Staff Report

To: Salt Lake City Planning Commission
From: John Anderson, 801-535-7214, john.anderson@slcgov.com
Date: October 12, 2016
Re: PLNPCM2016-00585 Dixon Medical Office Building Conditional Building and Site Design Review

Conditional Building and Site Design Review

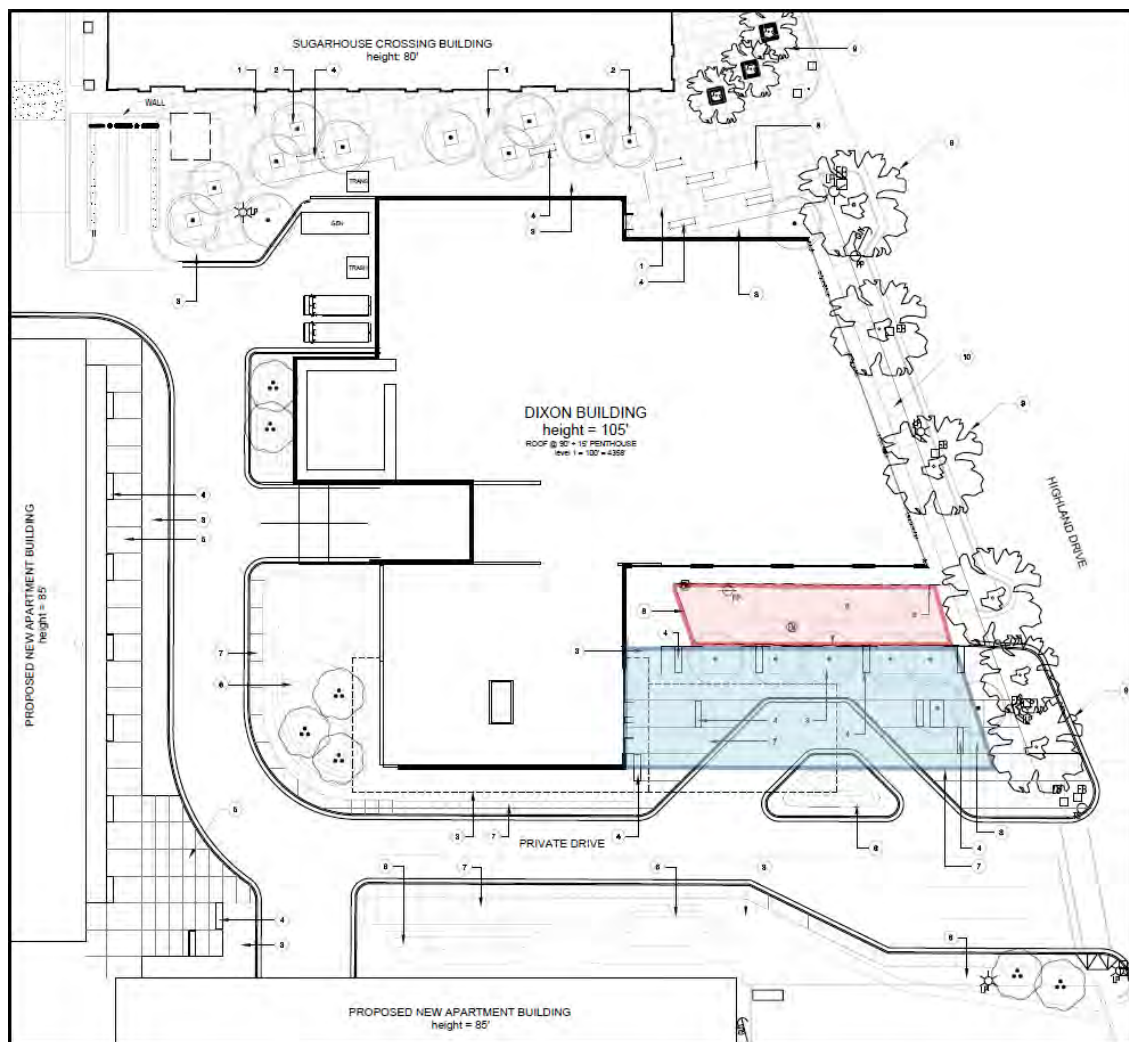
The applicant requests to modify one requirement of the Zoning Ordinance for this project. The request is to exceed the maximum front or corner side yard setback of 15 feet. This is due to the site construction difficulties posed by the remaining “The Bar in Sugarhouse” which the building is being constructed around. This will be discussed in more detail below in the “Key Issues” section of this report.

In the image above, the area shaded in red indicates the location of the bar discussed in the report. The area shaded in blue indicates that area of the structure that is proposed to not meet the maximum front yard setback.

ATTACHMENT B: SITE PLANS

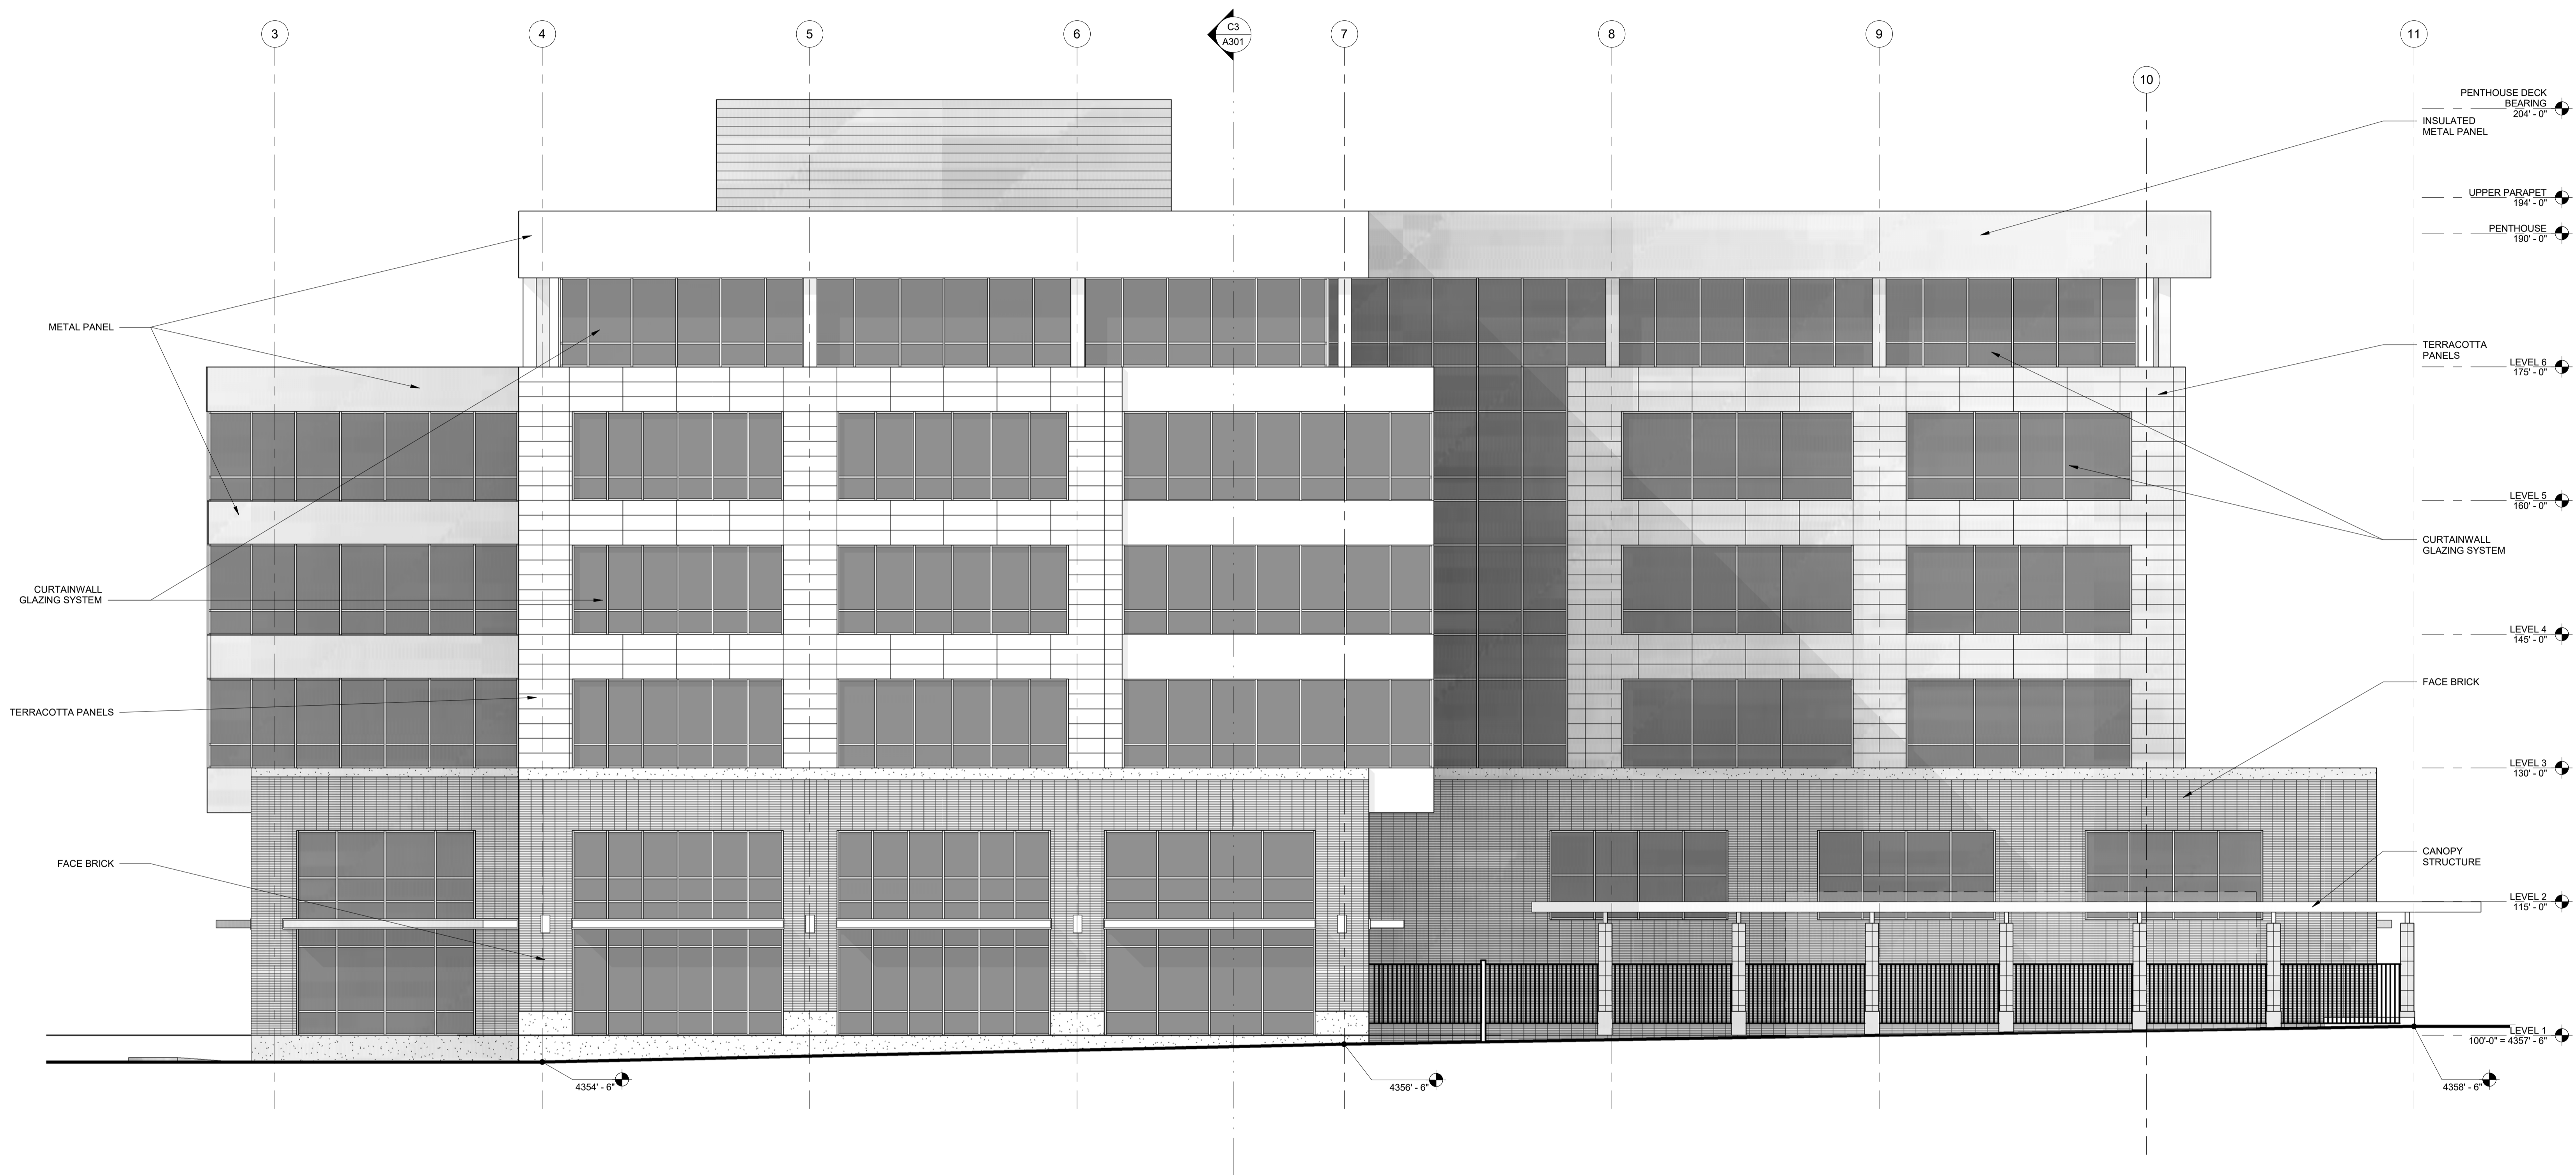
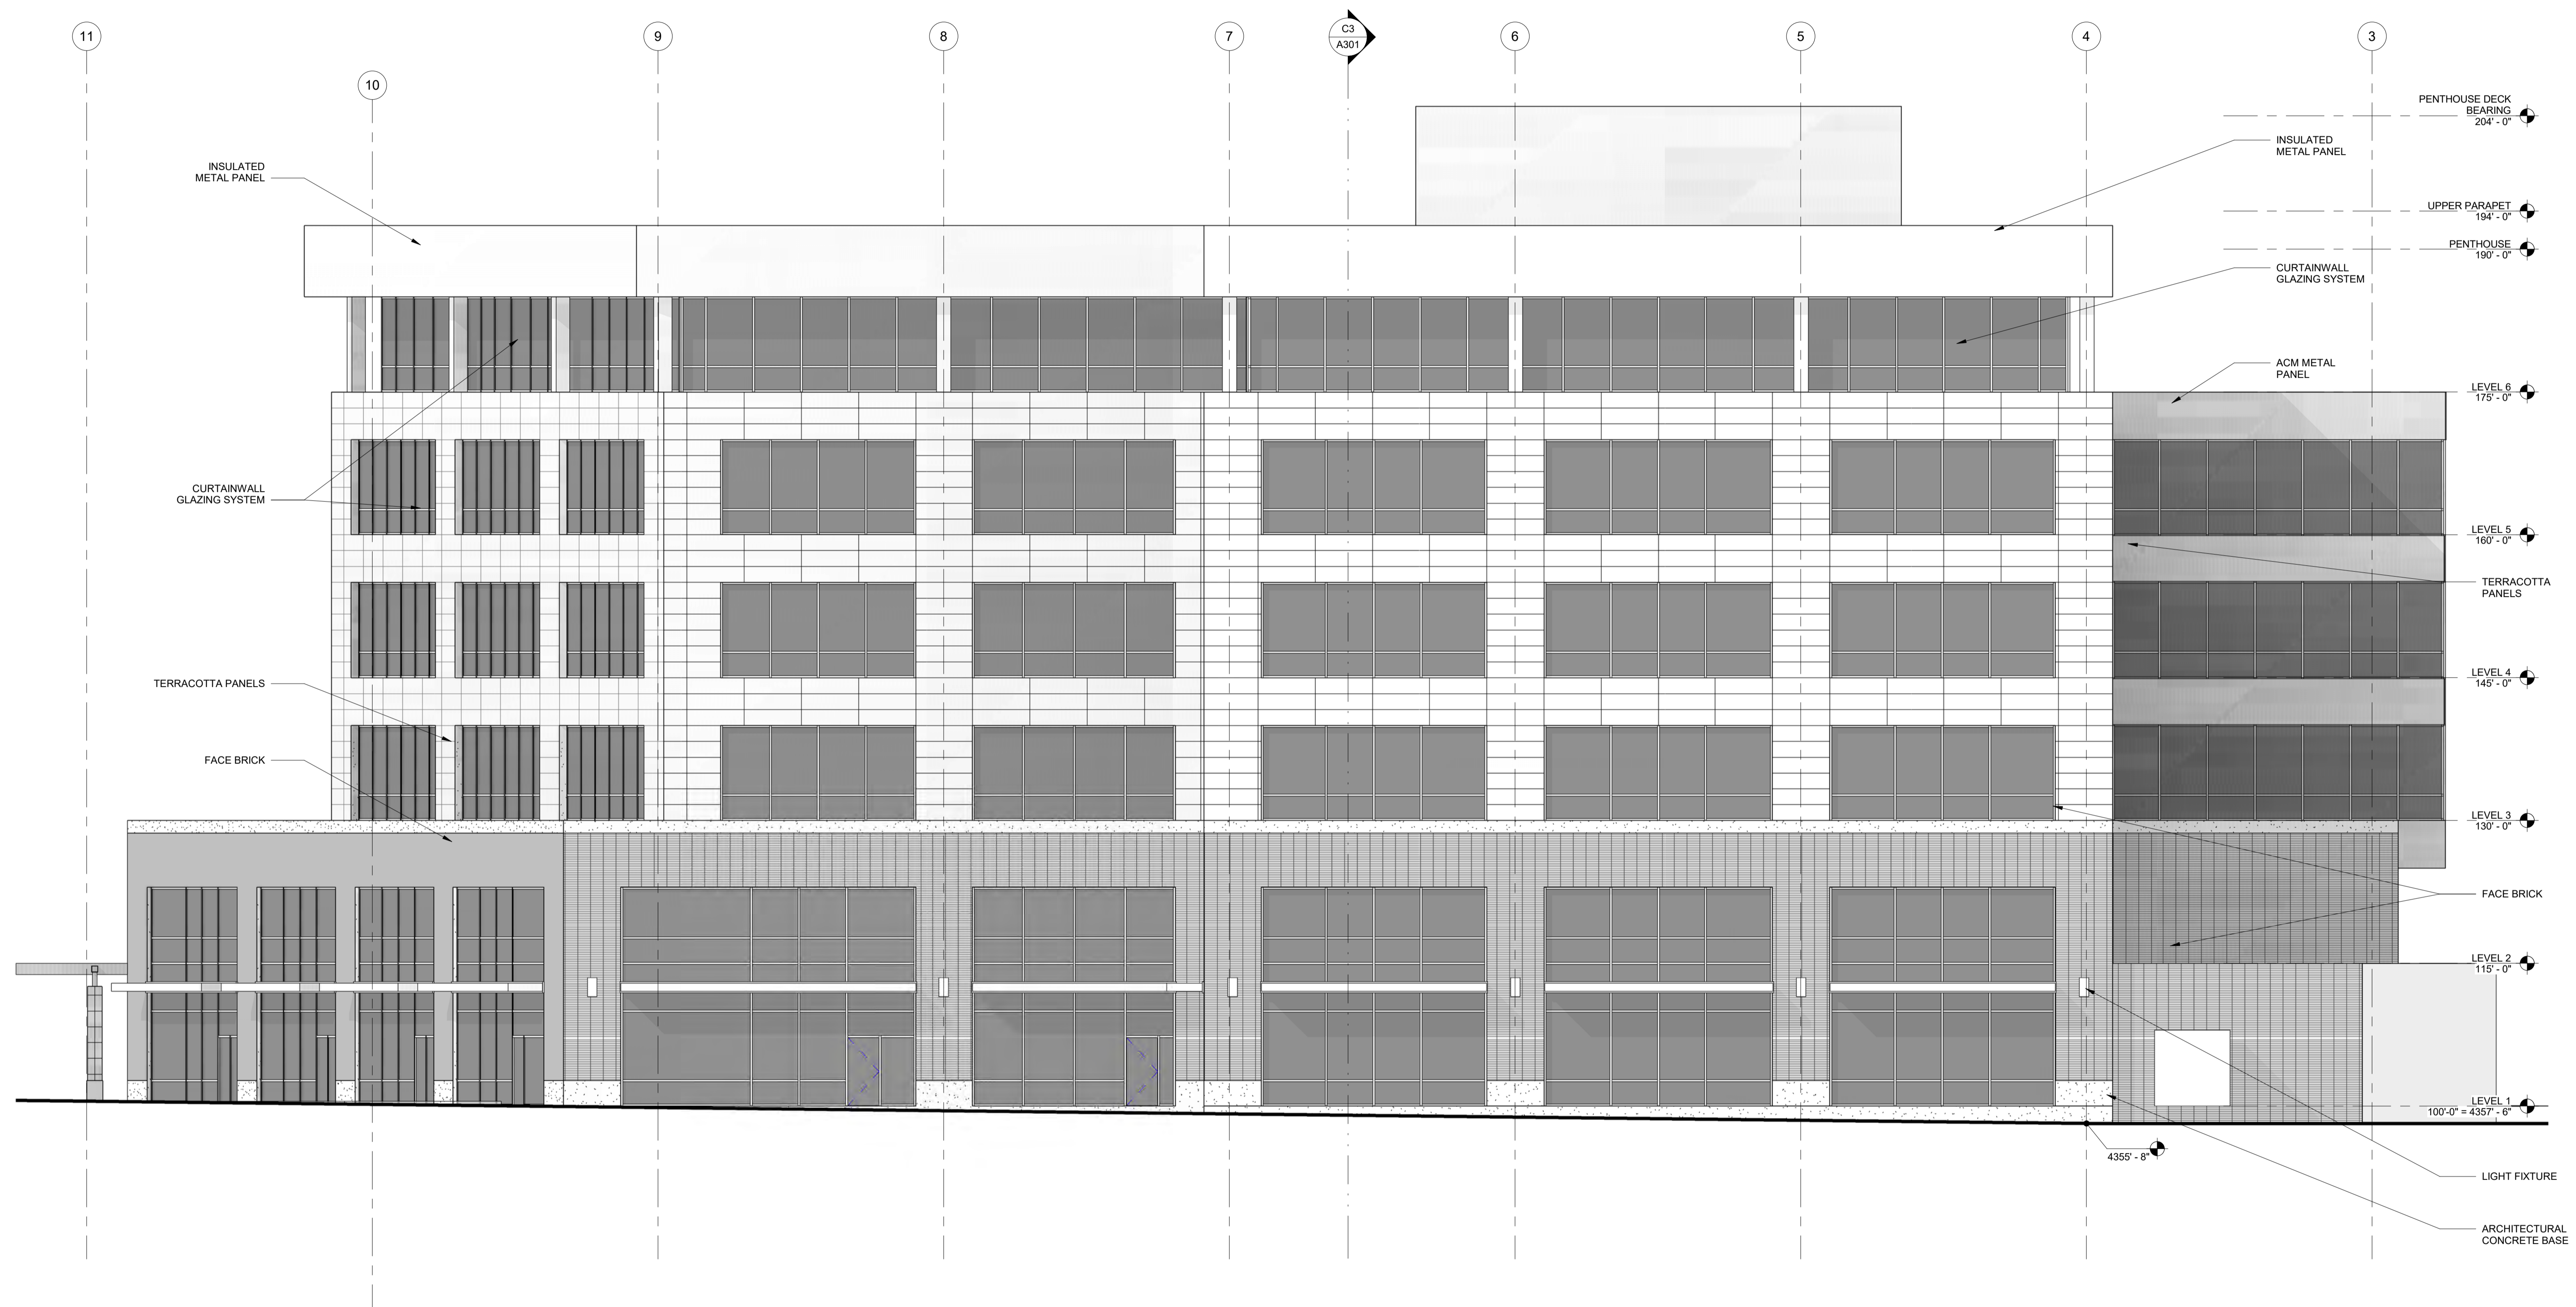
Planning Division Comment: Please provide more information regarding the circulation on the site. It is not clear that pedestrians will be able to safely cross the proposed private street especially those that utilize mass transit to access the site. Also Boulder Ventures has provided a more detailed plan for the development of the walkway located on the west side of this property. Please verify whether or not this walkway will be developed in a manner that has been presented to staff. Moving pedestrians safely through the Granite Block has been a critical issue raised by the community.

Planning Division Comment: It appears that the loading docks will be located in the rear of the structure. Will these loading docks be screened as well?

Planning Division Comment: Staff cannot verify that this standard has been met. Please provide a more detailed landscaping plan.

Planning Division Comment: Staff cannot verify that this standard has been met. Please provide a more detailed landscaping plan and the amount of the property that will be landscaped.

FFKR Response: Please see the attached updated AS101 Site Plan: note that the proposed design includes crosswalks across the private drive that are raised to adjacent sidewalk levels in an effort to slow vehicular traffic and provide safe passage for pedestrians utilizing mass transit to access or move through the Granite Block. Also note that the walkway along the south and west sides of the drive have been developed in collaboration with Boulder Ventures, including the incorporation of paving patterns, planters, bollards, and seating elements to connect the three adjacent properties (Sugarmon, Dixon, and The Vue) and encourage safe and stimulating pedestrian passage.

FFKR Response: Please see attached, updated AS101. The proposed building will screen the loading dock on the south side, and site walls will screen the dock from the pedestrian plaza to the north and west. The actual loading dock will be located in a recessed section of level 1. The truck entrance to the dock area will be the only area open to view.

FFKR Response: Please see attached updated AS101

FFKR Response: 180,000 GSF total building area x10% = 18,000 sf public spaces required. 35,525 sf of landscape, plaza and public space provided. Please see attached site plan with those plaza and landscaped areas shaded. The plazas shall incorporate the following elements: sitting spaces that comply with K.a.ii.1, K.a.ii.2, K.a.ii.3.
